South Texas Project
Units 3 and 4
Docket Nos. 52-012 and 52-013
Response to Requests for Additional Information

The purpose of this letter is to respond to the NRC staff's Request for Additional Information (RAI) letter number 61 related to South Texas Project Units 3 & 4 Combined License Application (COLA) Part 2, Tier 2 Section 17.5S, and "STP 3 & 4 Quality Assurance Program Description" (QAPD) Part II Section 1. Attached is the response to the RAI Question number 17.5-8. This submittal completes the response to RAI letter number 61.

RAI 17.5-8**QUESTION:**

Figure II.1-1 STPNOC Construction/Pre-operation Organization

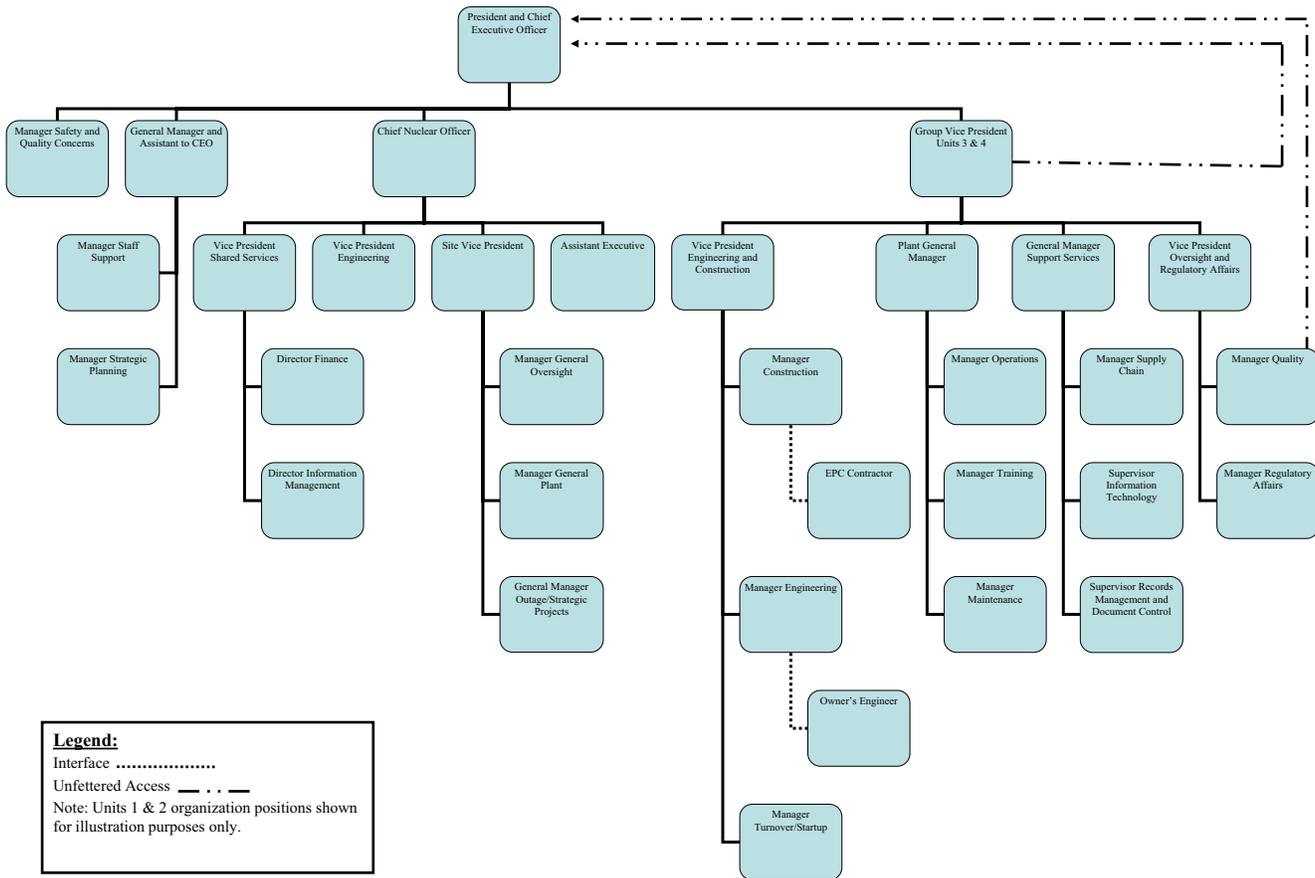
- b) The STP QAPD describes the functions and responsibilities associated with the quality assurance requirements of Appendix B, Criteria I, Organization and Criteria II, Quality Assurance. All positions associated with the establishment, implementation, and verification of quality-related activities should be shown on the organization charts and described in the QAPD. For the operations phase, the level of detail to be included should include roles, responsibilities, and lines of authority for the positions necessary to implement the requirements of Appendix B. Comparable detail should be provided for the construction/preoperation phase.

In addition, please provide 2) position descriptions, including roles, responsibilities, and lines of authority, for all positions identified in the STPNOC Units 3 and 4 Organization Chart. Section I, Organization, does not include position descriptions for the Operations Manager, Training Manager, or Information Technology Supervisor. Please identify in the Organization Chart (if not already done) positions that are necessary to support managerial roles such as the Plant Manager. In addition, please include in the QAPD a complete description of these positions, including the EPC Design Engineer and the Owner's Engineer, who interface with the Engineering Manager.

STPNOC will replace Part II, Section I of the QAPD with the following Part II, Section I, including functional responsibilities of the organizational positions shown in Figure II.1-1 and Figure II.1-2 and clear delineation of these responsibilities from the construction/preoperation phase through the transition to the operations phase. This response supersedes the response previously provided to RAI 17.5-6. In addition, the organizational charts (Figures II.1-1 and II.1-2) being provided in this response supersede those previously provided in response to RAI 17.5-1.

The STPNOC (Units 3 & 4) construction/preoperation organization is shown on Figure II.1-1. The STPNOC (Units 1 & 2) organization is shown to illustrate the overall STPNOC company structure. Figure II.1-2 illustrates the STPNOC organization after transition to the operations phase.

The following roles and responsibilities correspond to those positions shown on Figure II.1-1 and are applicable during the construction/preoperation phase.
